Resource consent application – Further information request

Application number(s):	BUN6044955 / DIS60449556 / LUC604449557
Applicant:	Taha Auto Limited
Address:	395 Fitzgerald Road, Drury, Auckland
Proposed activity(s):	The construction of two new warehouses and associated earthworks within the Future Urban Zone to provide for a vehicle dismantling and storage activity.

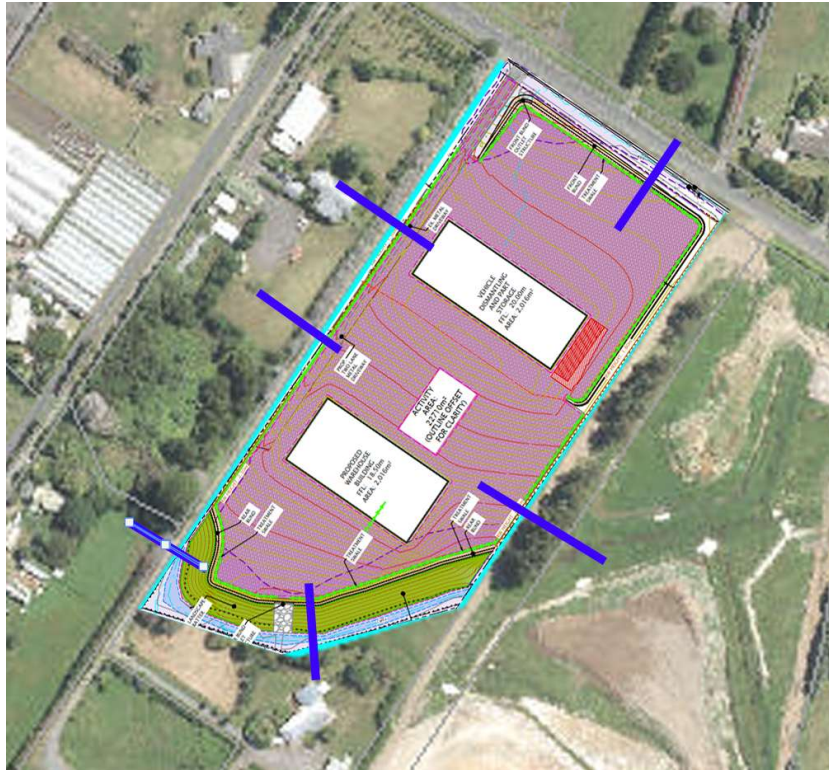
- If “yes,” please provide an assessment of the proposed signage against the rules of the AUP(OP).
43. Please provide cross sections through the site illustrating the relationship between the proposed buildings, external storage area, existing and / or proposed planting and neighbours. This should indicate any proposed planting at the height of time of implementation and then at 5 years. See Figure below for indicative locations.

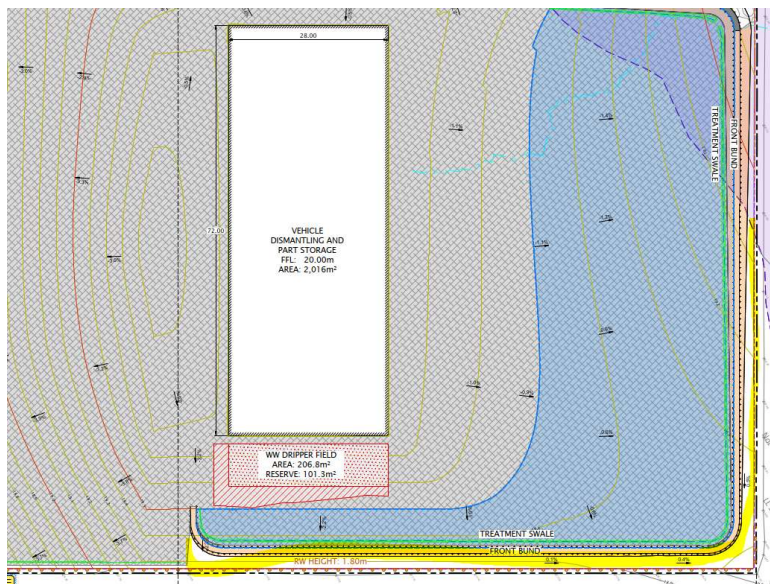
44. Please provide visual montages of the proposed earthworks/landform changes, storage area and buildings proposed on site from viewpoints 1 and 2 provided within the Landscape and Visual Effects Assessment. These should be accurate as possible, with one image showing at completion of works and another showing any proposed planting at 5-years growth.
45. Please provide perspectives / visual montages from the adjacent properties towards the proposal, the images should demonstrate accurately the proposal (buildings, landform changes, structures, fencing, planting, lighting etc) at eye level. See figure below for locations.
